**U.S. Nuclear Regulatory Commission Request for Additional Information  
Uranium One Americas Antelope and JAB Uranium Project  
Environmental Review of Application for a U.S. Nuclear Regulatory  
Commission Source Materials License**

Uranium One Americas (Uranium One) submitted a source material license application on July 3, 2008, to the U.S. Nuclear Regulatory Commission (NRC) for the Antelope and JAB Uranium Project (Uranium One, 2008a, 2008b). This application, which included an environmental report (Uranium One, 2008c), is to allow Uranium One to conduct *in-situ* recovery (ISR) operations for uranium extraction at Antelope and JAB (a satellite to Antelope), both in Sweetwater County, Wyoming. Based on a review of the environmental report, the NRC staff offers the following Request for Additional Information (RAI). In this RAI, staff refers to the Antelope and JAB Uranium Project, which consists of the Antelope Unit and the JAB Unit. Each information request may refer collectively to Antelope and JAB Uranium Project or individually to the Antelope or JAB unit, and includes the basis and purpose for requesting the information. Information requests are organized by environmen

Figure 2-7. Proposed Well Field Layout at the Antelope Unit [RAl: To Provide Well Field Layout]

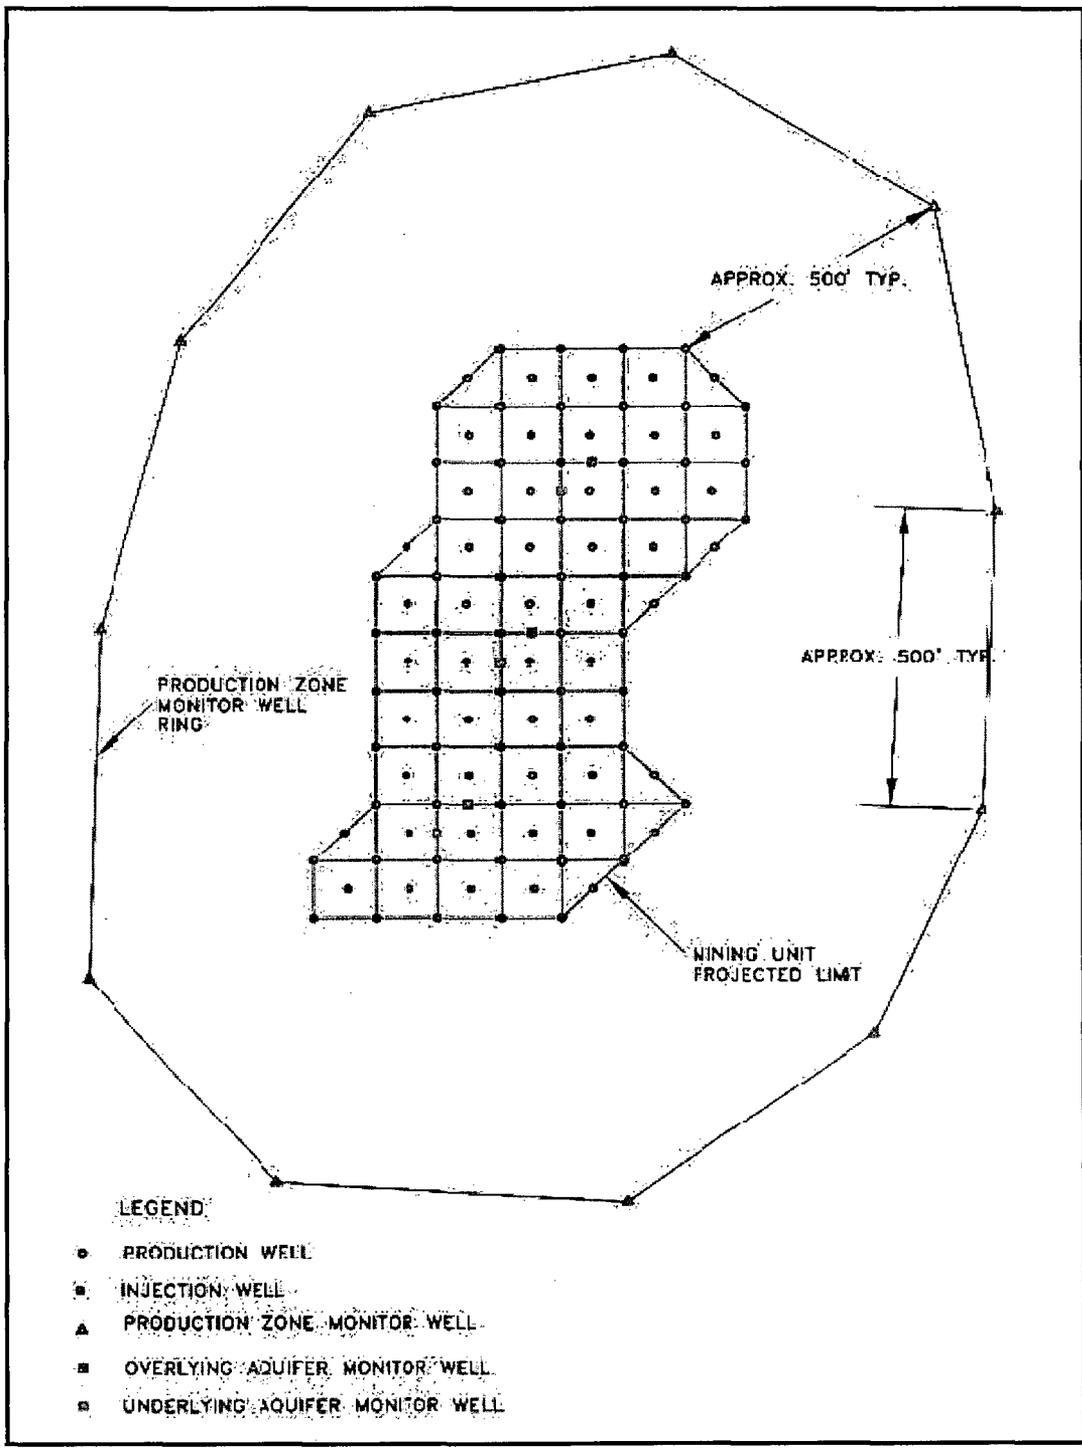
shown in Figure 2-6. The pattern contains four injection wells, placed 23 to 46 m [75 to 150 ft] apart, surrounding a central recovery well. Estimate of how many injection and production wells are needed? **[RAIPA-1 to provide well field layout.]** The actual well placement would depend on the characteristics of the ore body. Each well will be constructed to be used for both injection and recovery, allowing for flow patterns to be modified as necessary to improve uranium recovery during production and to improve groundwater restoration during reclamation. Recovery flows will be at a maximum rate of approximately 190 liters per second (L/s) [3,000 gal per minute (gpm)] for each project area, including a production bleed of about 2 L/s [30 gpm]. Restoration flow capacity will be approximately 63 L/s [1,000 gpm] for the Antelope unit and 32 L/s [500 gpm] for the JAB Unit. **[RAI PA-1 to provide the current well field plan]**

Horizontal and vertical excursion monitoring wells would be installed at each well field as dictated by geologic and hydrogeologic parameters. The horizontal monitoring wells would be located in a ring around the well fields, approximately 152 m [500 ft] from the pattern area and with 152 m [500 ft] spacing between monitor wells. One vertical monitoring well for underlying and overlying aquifers would be installed for every 1.6 ha [4 acres] of well field area. Figures 2-7 and 2-8 show the proposed monitoring well locations for the Antelope Unit and JAB Unit, respectively. Estimate of how many monitoring wells are needed? **[RAI PA-1 to provide well field layout.]**

Figure-2-11. JAB Satellite Plant Process Flow Diagram (Uranium One, 2008)

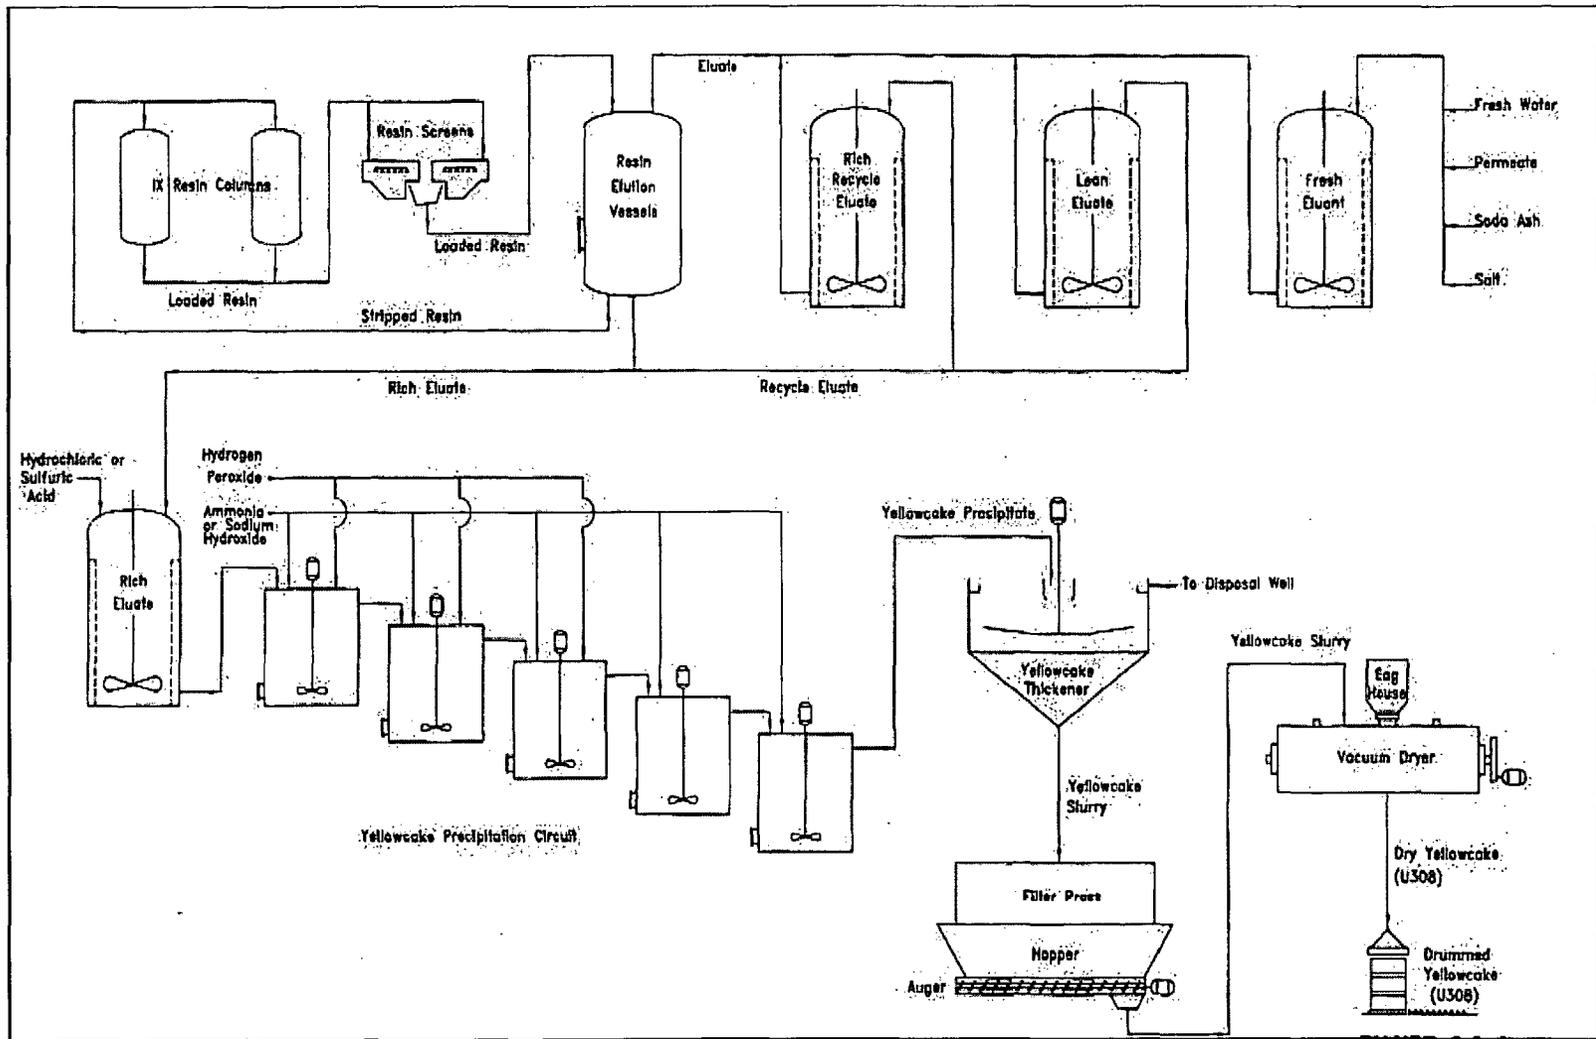
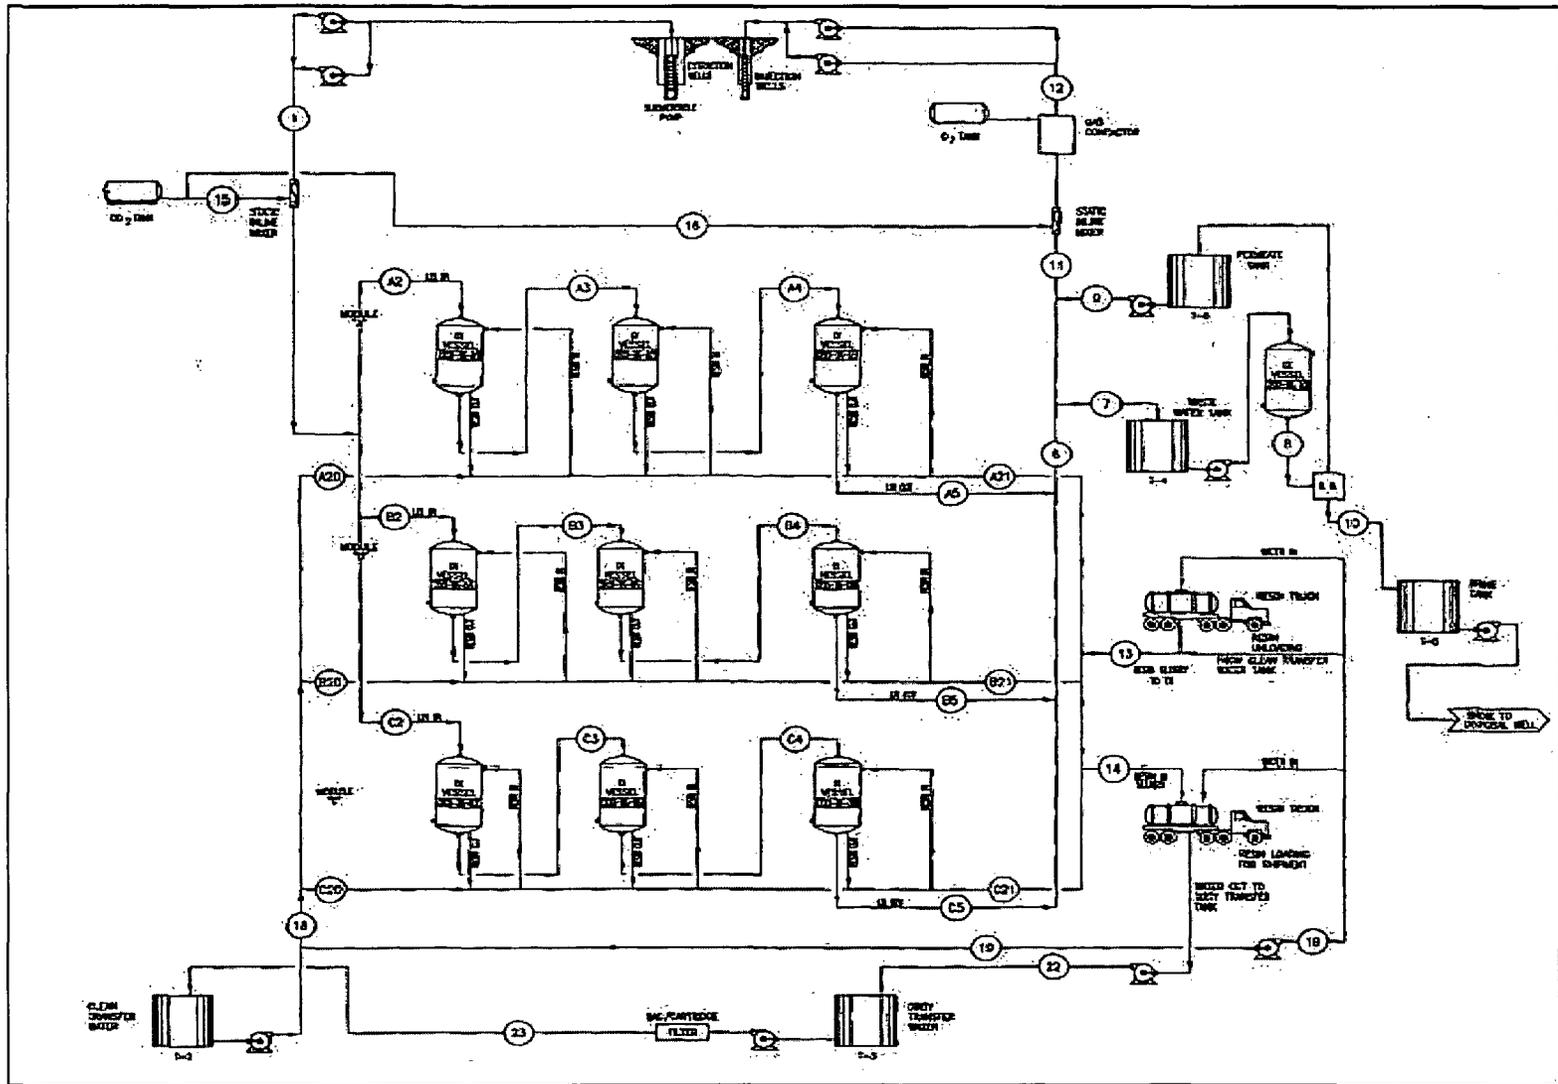
**[RAI PA-2 to clarify inconsistency between illustration in Figure 2.2-7 and process description in Section 2.3.1.3.]**

## Sage-Grouse Core Breeding Areas Version 2

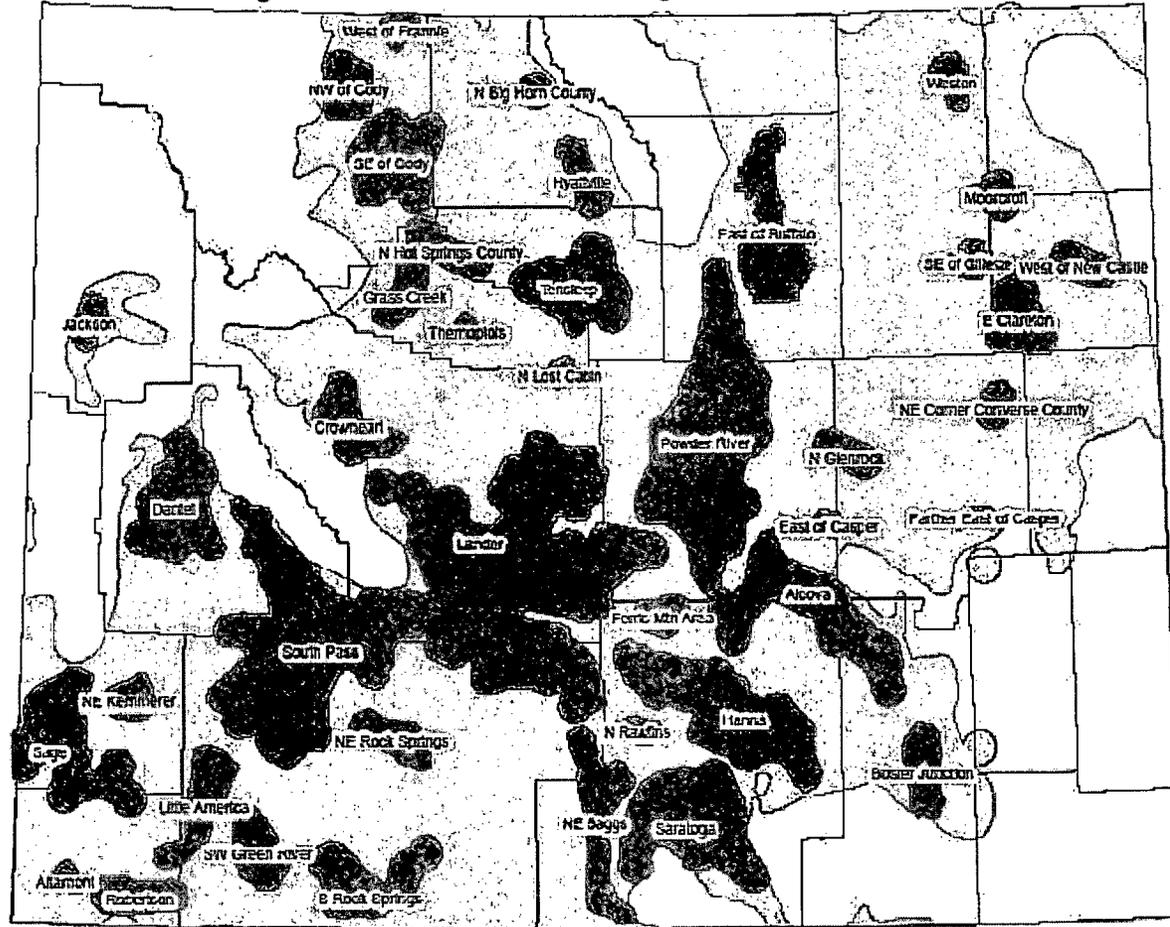
According to the Sage-Grouse Core Breeding Areas Version 2 map issued by WGFD, the proposed project areas are located within the designated core area (Figure 3.5-9) (WGFD, 2009b) **[RAI Wildlife-1 to provide location of project area in relation to sage-grouse core breeding areas]**. Based on information WGFD provided to NRC, the four sage-grouse leks located within 3.2 km [2 mi] of the permit boundaries that were not identified in Uranium One's ER are the Osborne Draw lek (SESE Section 28, T26N, R93W), Eagles Nest Draw lek (NWSE Section 1, T25N, R93W), an unnamed lek (Section 3, T25N, R92W), and Little Osborne lek (Section 31/32, T26N, R93W) **[RAI Wildlife-3 to provide sage-grouse lek locations]**. Locations of the 10 occupied sage-grouse leks that are within 3.2 km [2 mi] of the permit boundaries are shown on the Antelope Sage-Grouse Leks and Observations Map (Figure 3.5-10) and JAB Sage-Grouse Leks and Observations Map (Figure 3.5-11) provided by WGFD.

Figure 3.5-12. Te rre str ial Cr uc ial d an ial Co m bi ne d Cr uc ial Pri ori ty Ar ea S M ap (W G FD ' 20 09 b)

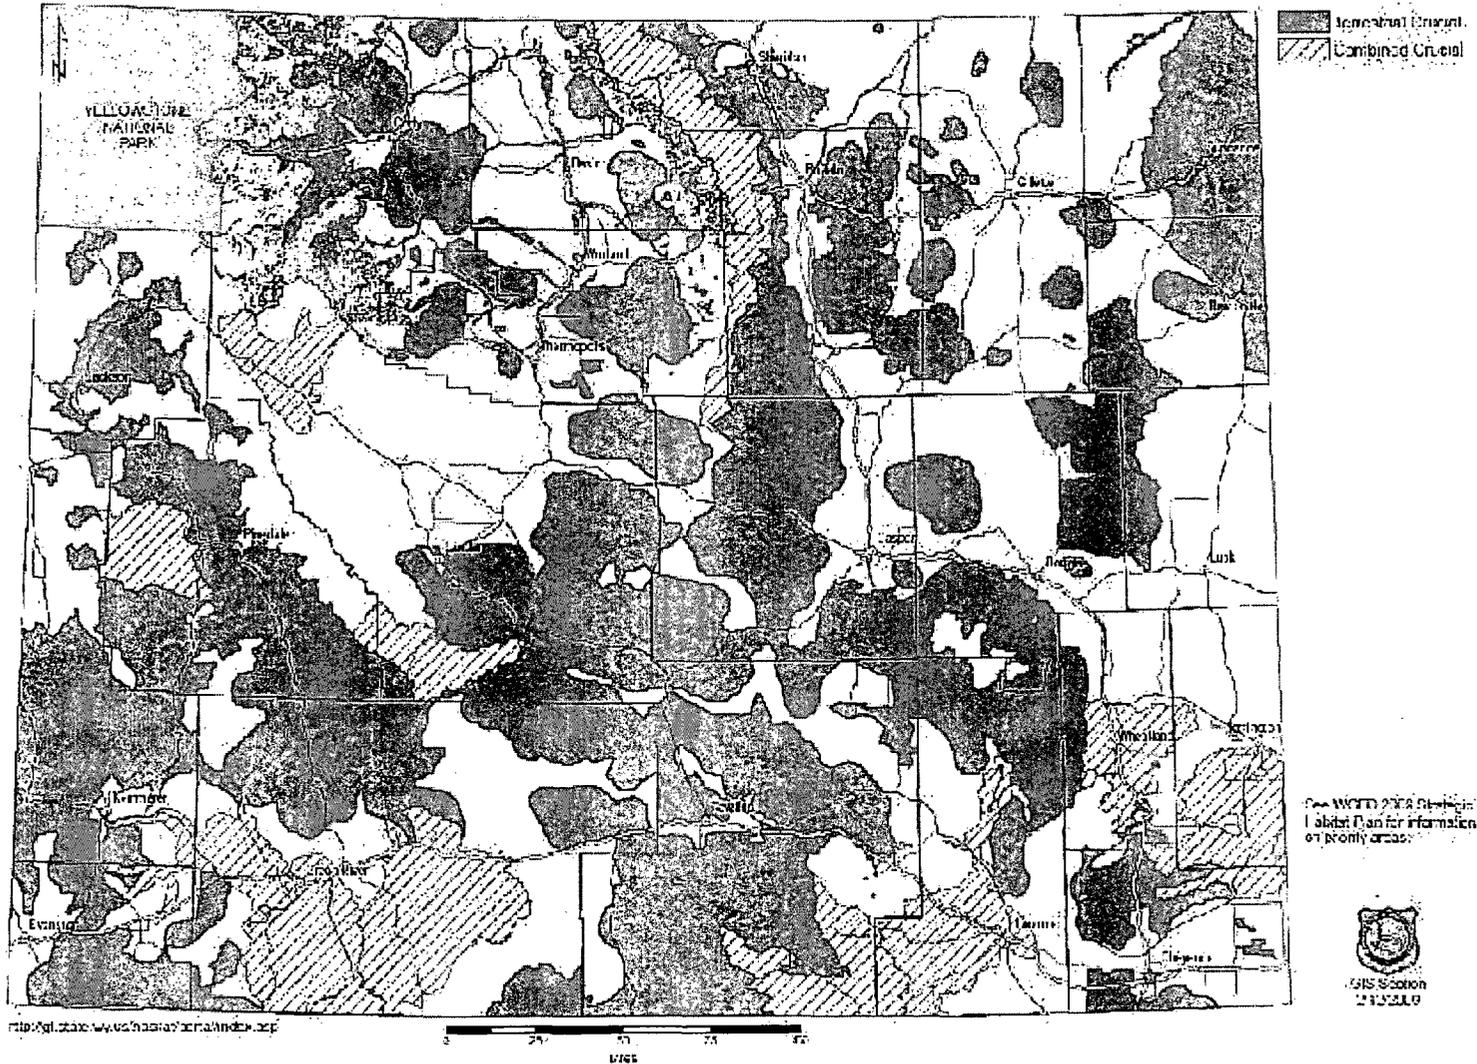
**Provide information indicating the location of the proposed Antelope and JAB permit areas relative to Wyoming Game and Fish Department Terrestrial Crucial Priority Areas. Consider referencing maps presented in the Wyoming Game and Fish Department Strategic Habitat Plan of January 2009.**

The requested additional information is needed to verify that the project area is within Terrestrial Crucial Priority Areas. The requested additional information is necessary to complete the analysis of the potential impacts to terrestrial wildlife.
